Preservation Department – Item 2, LPC-25-00834

94 Bank Street – Greenwich Village Historic District
Borough of Manhattan

Landmarks Preservation Commission Public Hearing

Summary of comments and changes

EXISTING CONDITIONS
NW VIEW

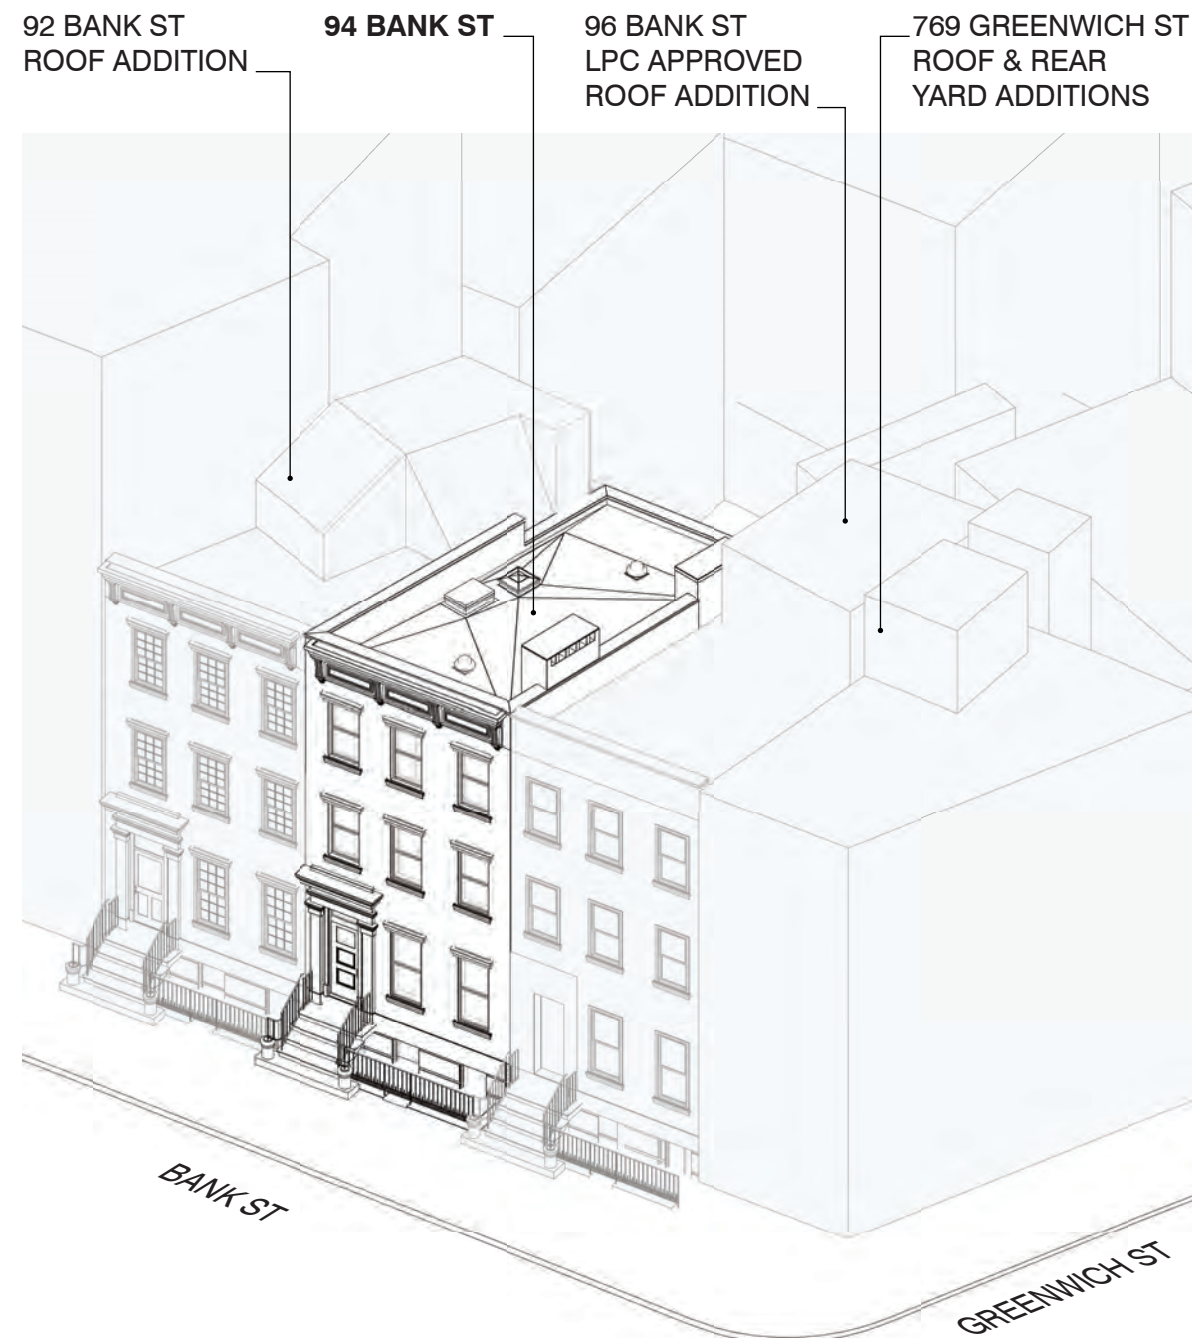
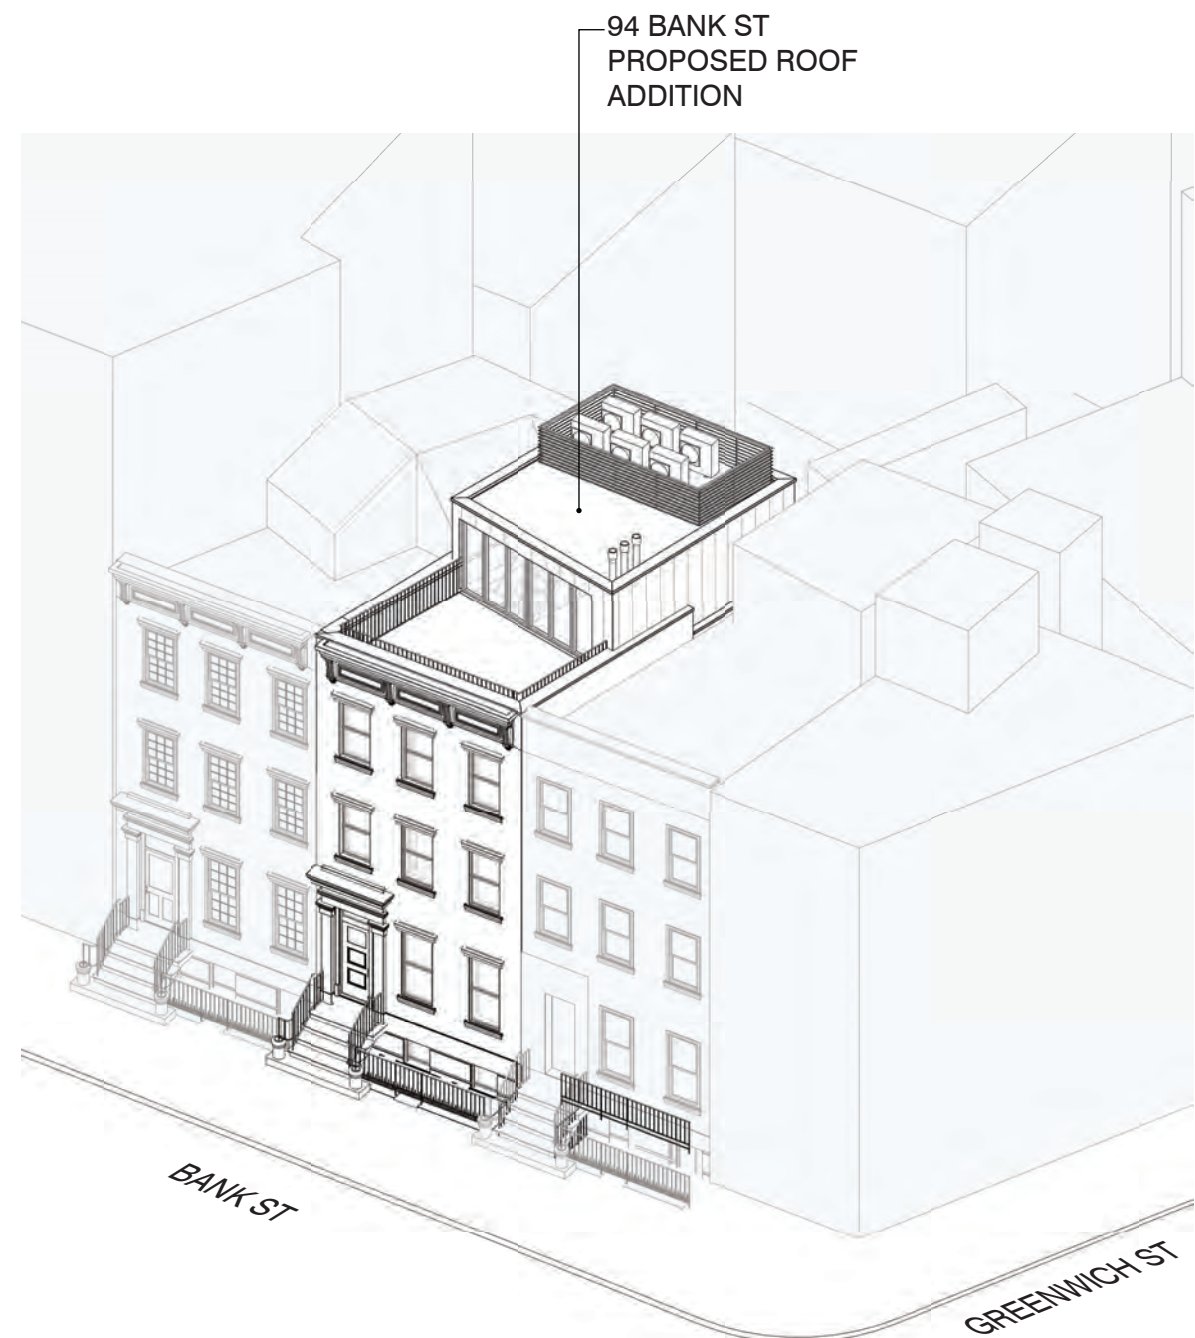
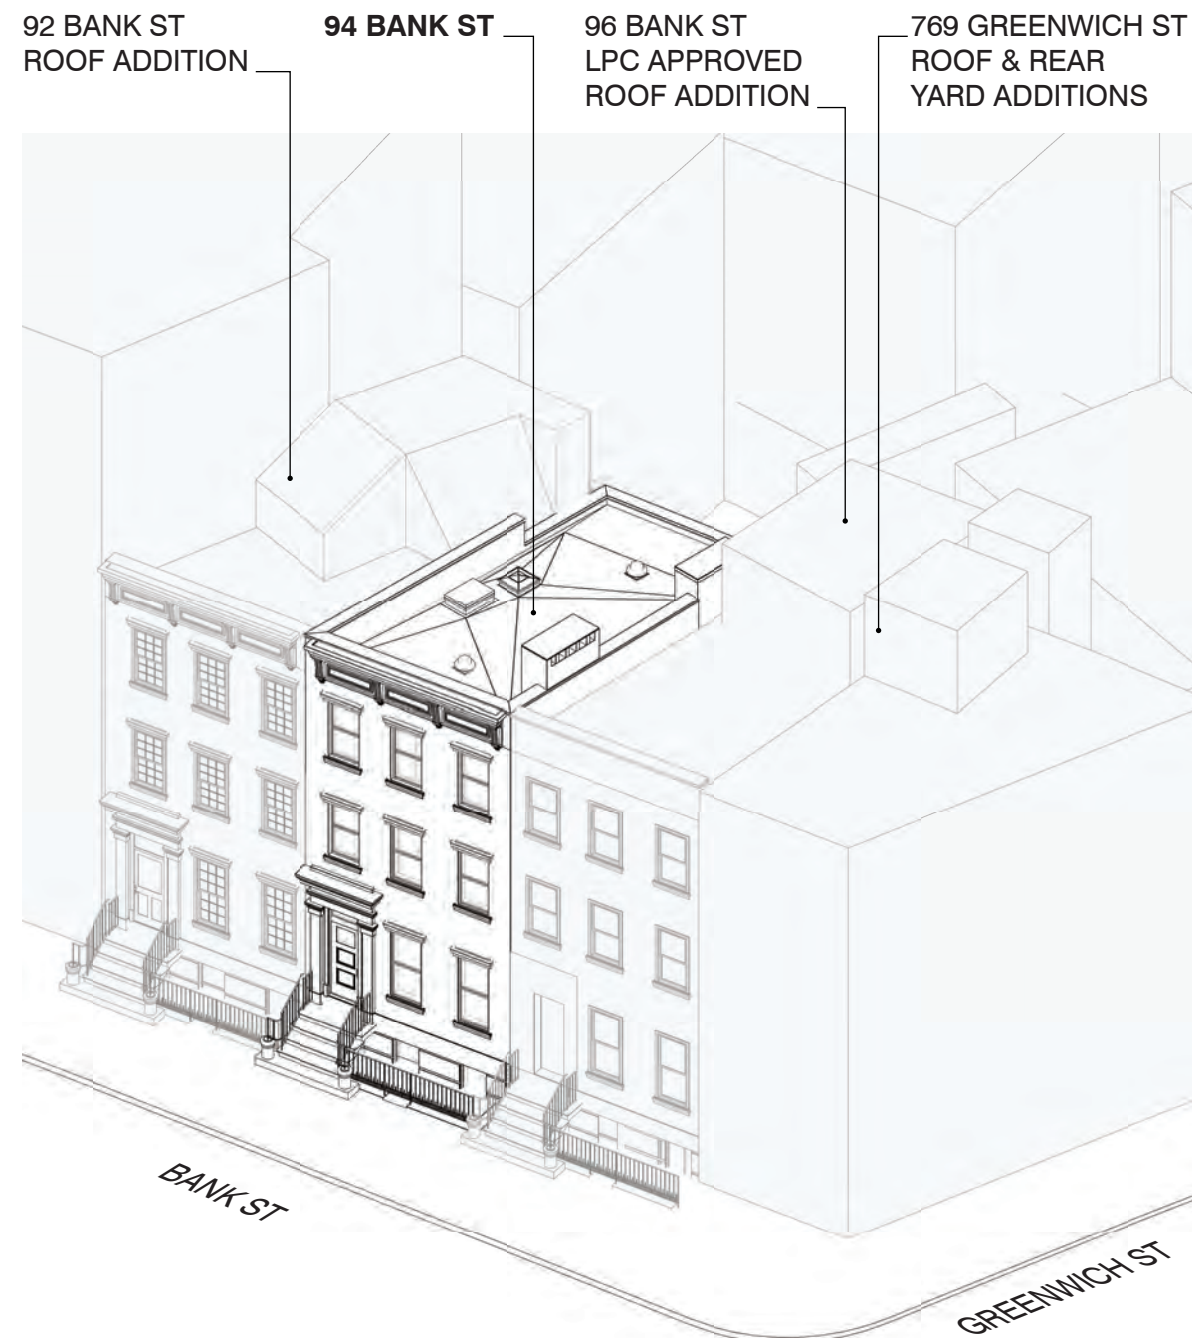
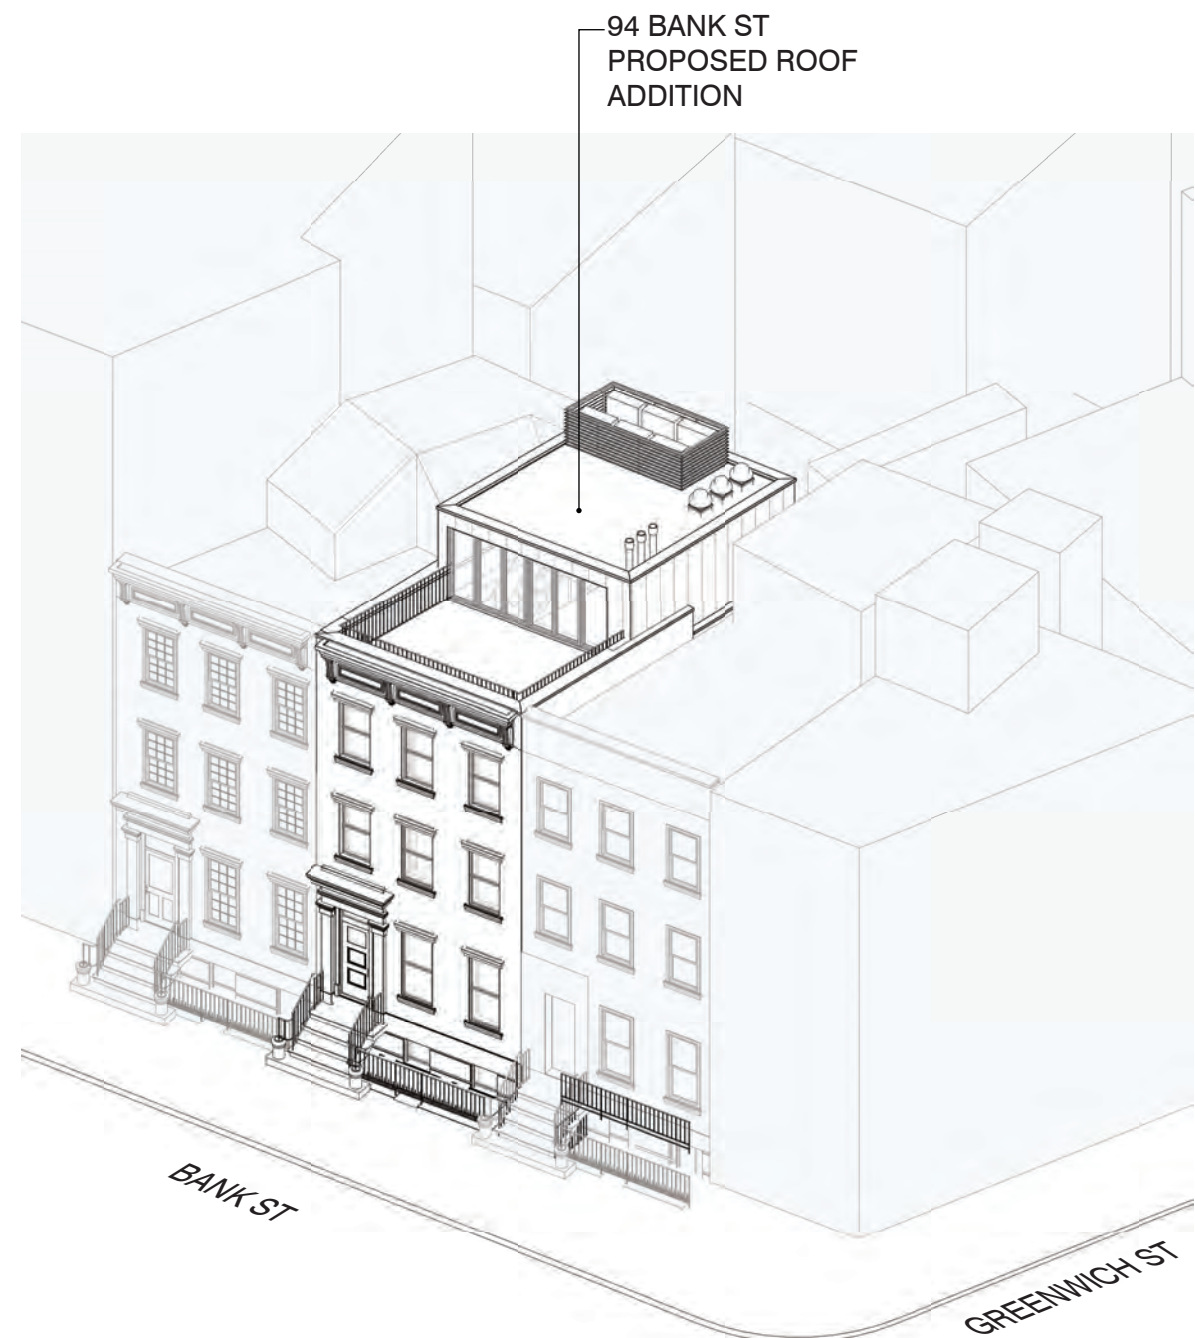
- Commissioners' comments: The angles of the rooftop and rear-yard additions do not respect the house's angles and create a discordant appearance.

Response: The angles of the rooftop and rear-yard additions have been rationalized to be in alignment with the house.

*BRICK CORNICE AT REAR
FACADE OF 92 BANK ST

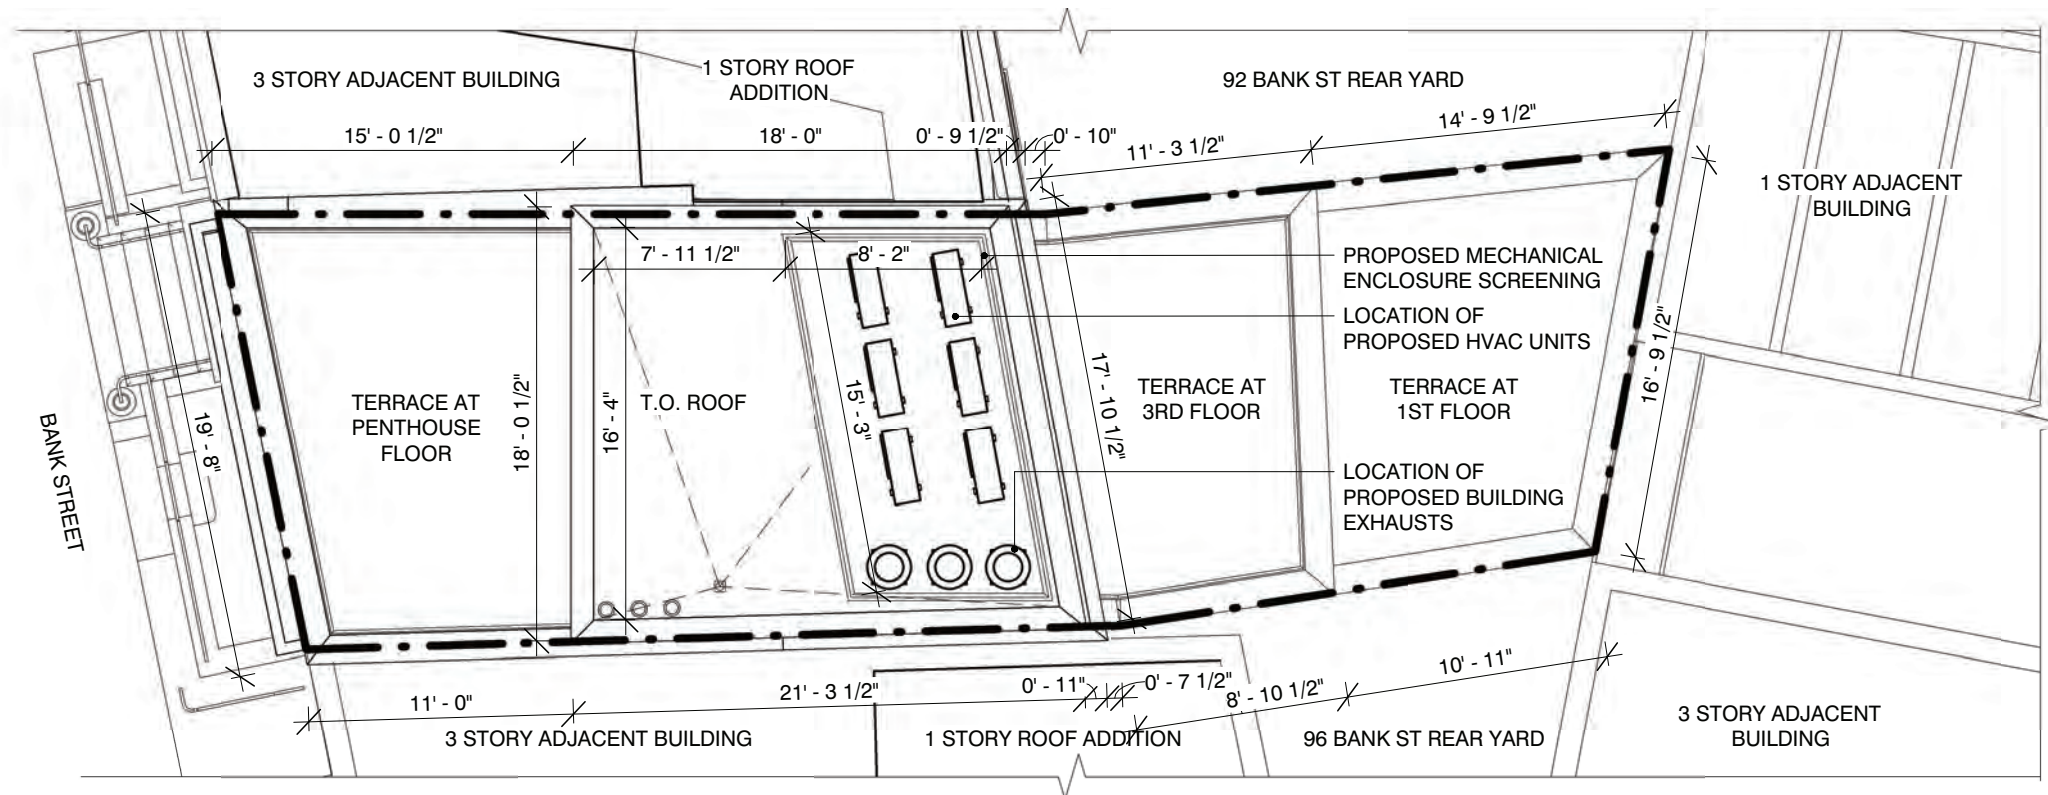
- Commissioners' comments: Rear elevation features should be reconstructed.

Response: The missing brick cornice is proposed to be reconstructed based on 92 Bank Street's. The top floor window lintels will be retained.

MOCK-UP VIEWS

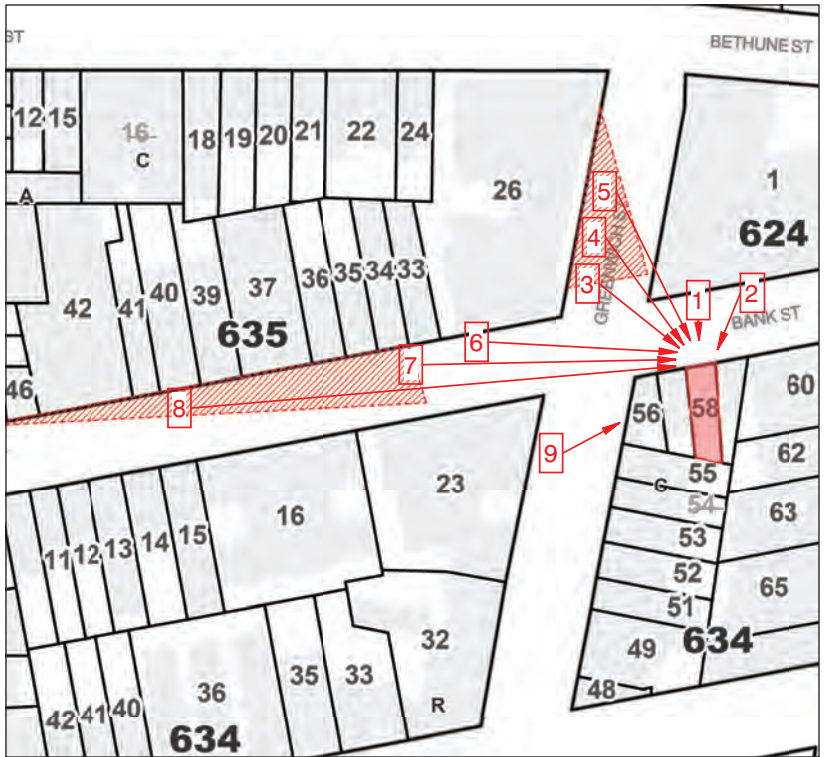
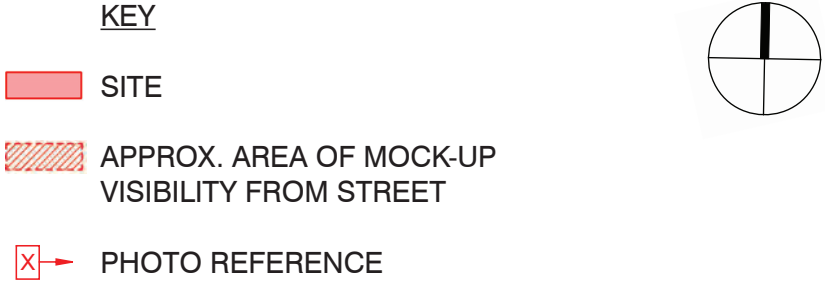
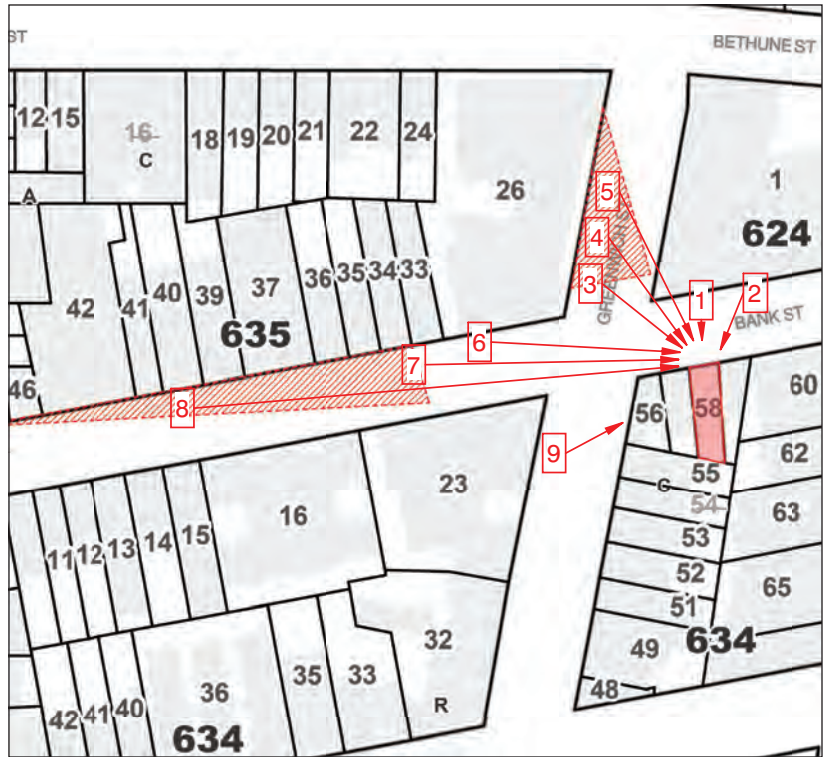
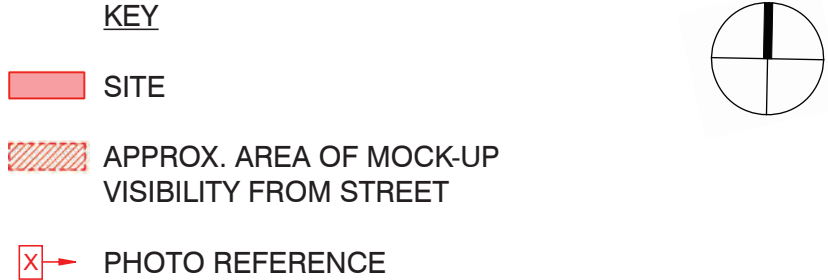
- Commissioners' comments: The visibility of the mechanicals should be decreased.

Response: The footprint of the mechanical enclosure has been decreased so that it is no longer visible from Greenwich St and Bank St.
